# Certificate of Appropriateness

<b>Property</b>	3005 W. KILBOURN AV.	<b>Concordia Historic District</b>
<b>Description of work</b>	Remove two wood frame dormers not original to the house on north and east slopes of roof. Restore wood rafters and decking in place of the dormers to match the surrounding roof surfaces. Replace deteriorated or missing valley rafters, common rafters and top plates in exterior walls as needed. Rebuild deteriorated masonry parapet on north elevation using salvaged brick in basement to match original. Install new architectural asphalt shingles. Install new EPDM or soldered metal on flat roofs. Remove rear, projecting wooden porch, which is deteriorated and not original to the house. Repair or replace deteriorated wood cornice to match original work. Install half-round rain gutters on eaves of main roof.	
<b>Date issued</b>	2/22/2013	PTS ID 82757 COA, amended roof restoration

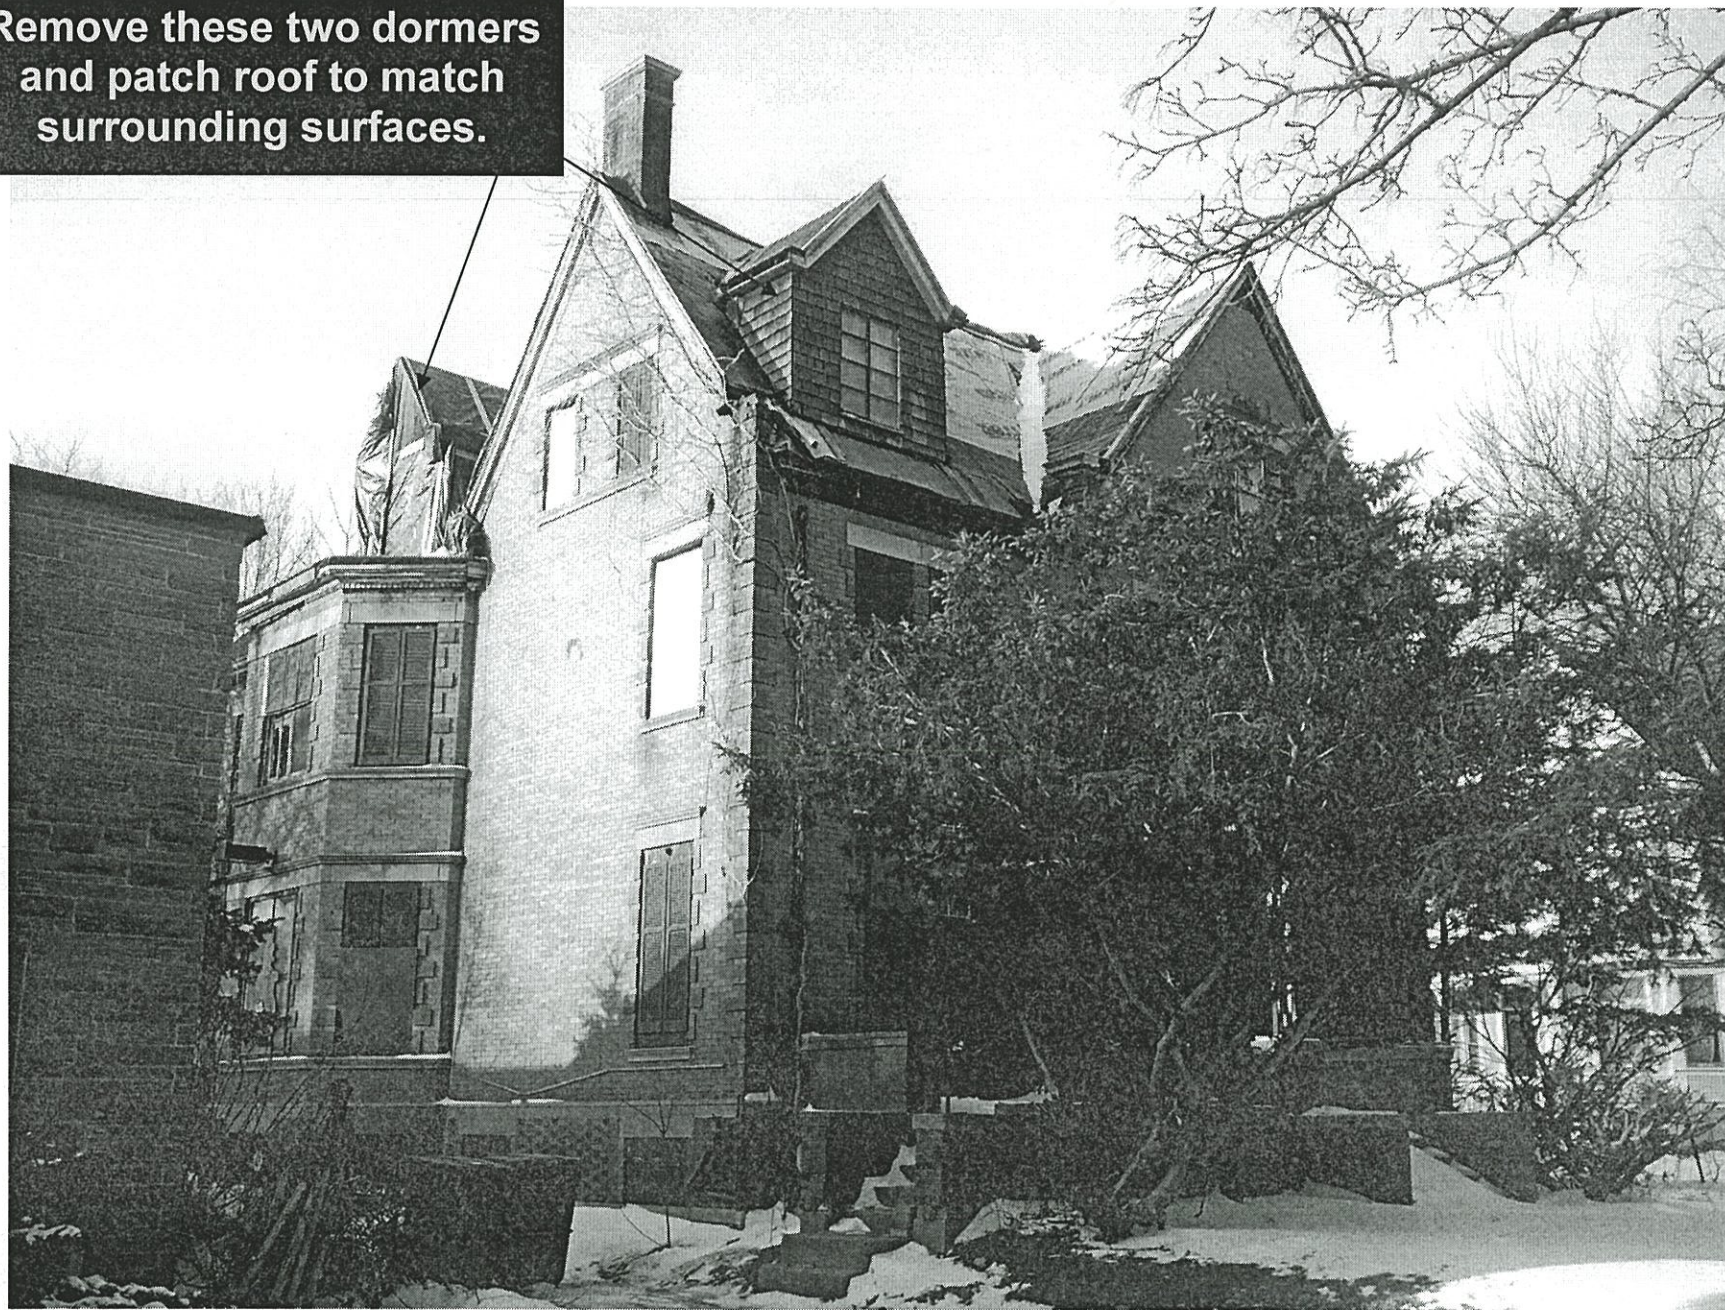
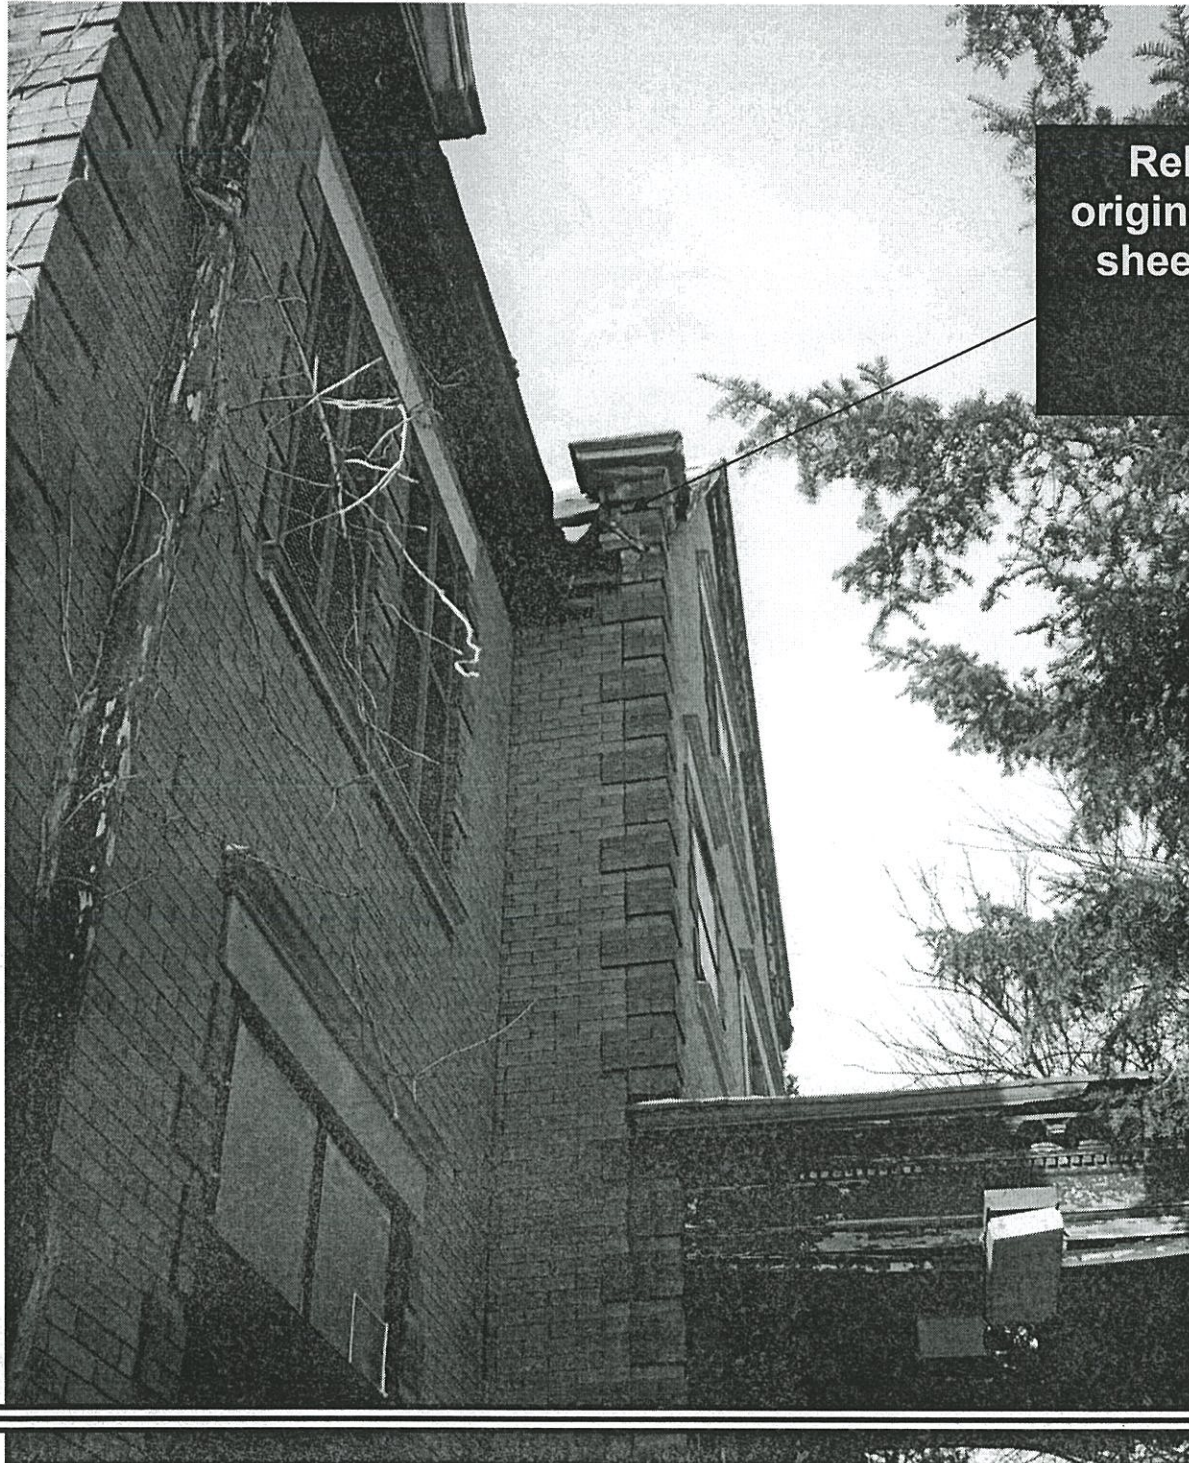
**Remove these two dormers  
and patch roof to match  
surrounding surfaces.**

**Rebuild parapet to match original and top with wood and sheet metal coping to match original.**

**Remove fire escape**

**Remove two-story, frame, rear addition which is severely deteriorated and not original to the house. Secure basement and rear entry.**

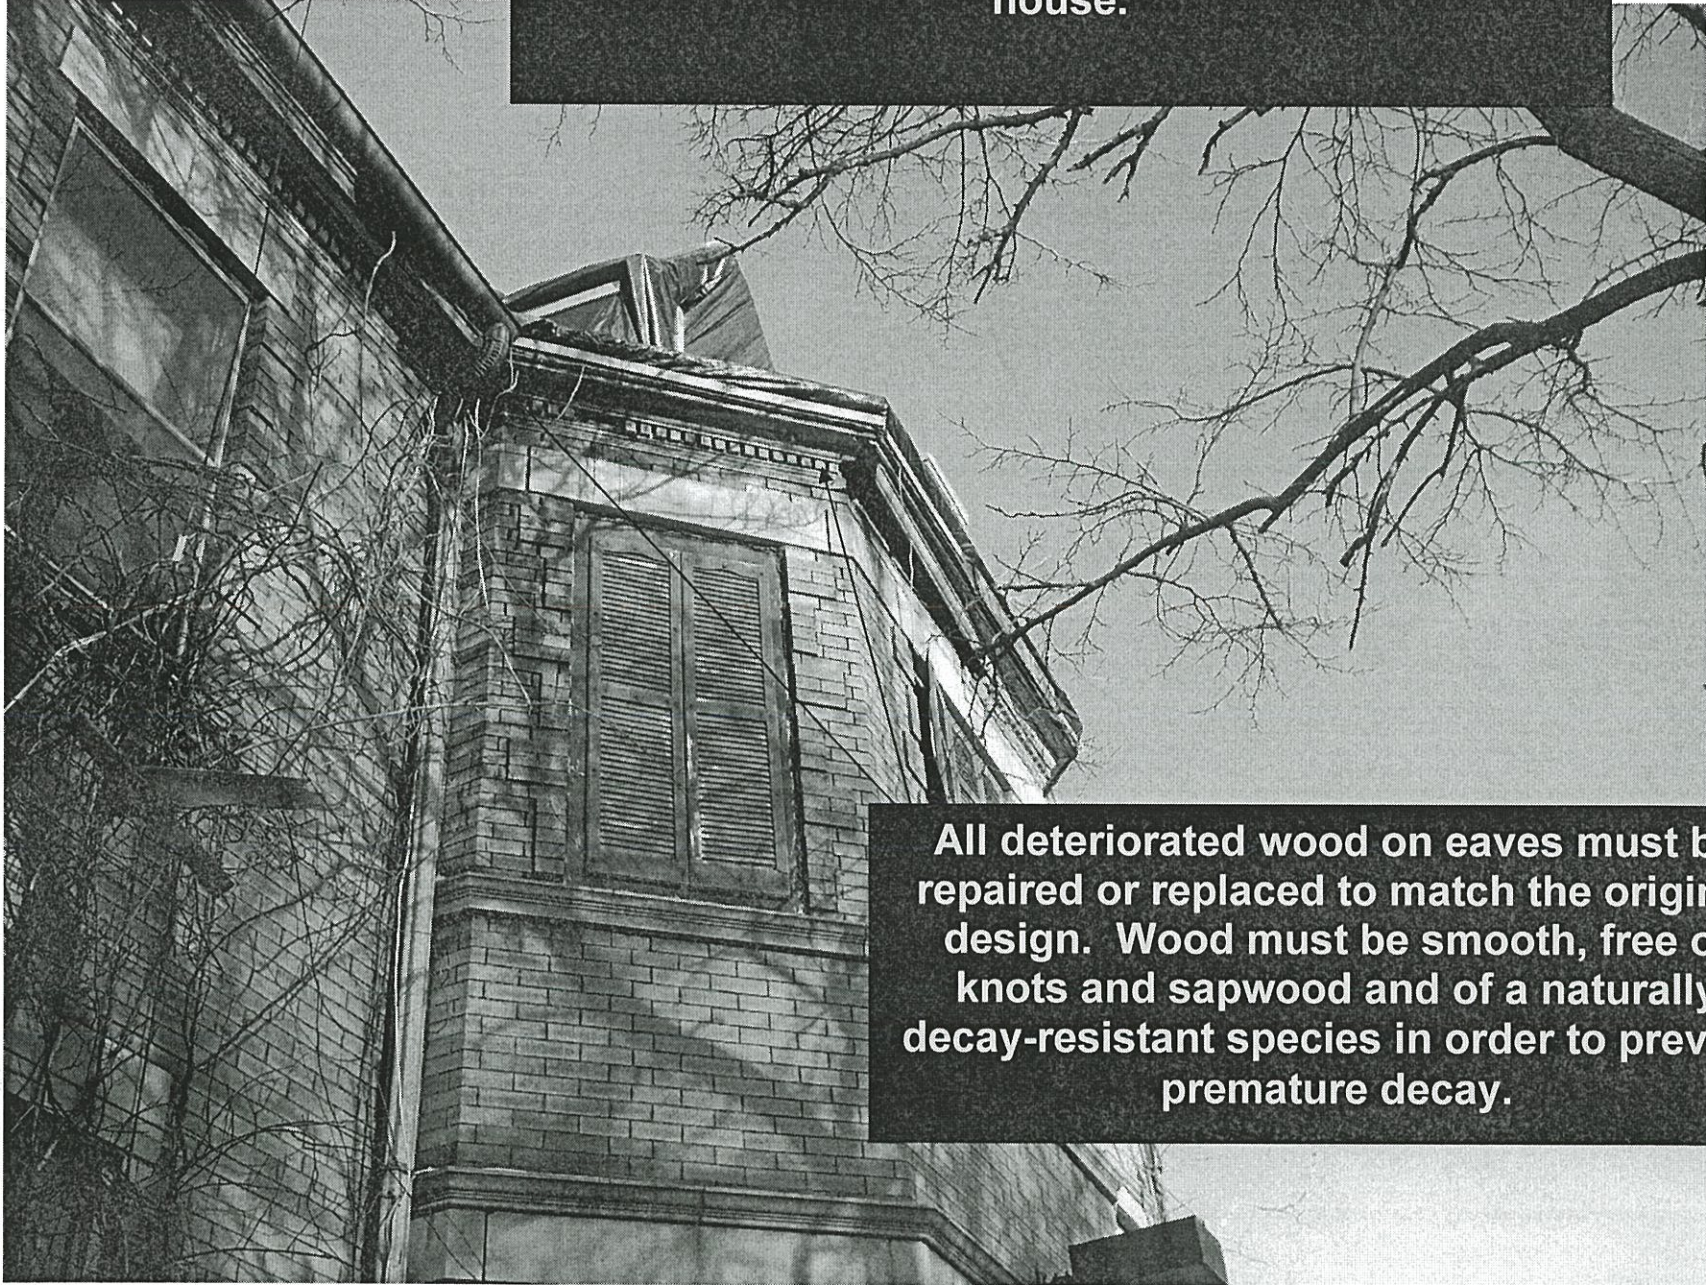
**Half-round rain gutters to be installed on main roof house.**

**All deteriorated wood on eaves must be repaired or replaced to match the original design. Wood must be smooth, free of knots and sapwood and of a naturally decay-resistant species in order to prevent premature decay.**
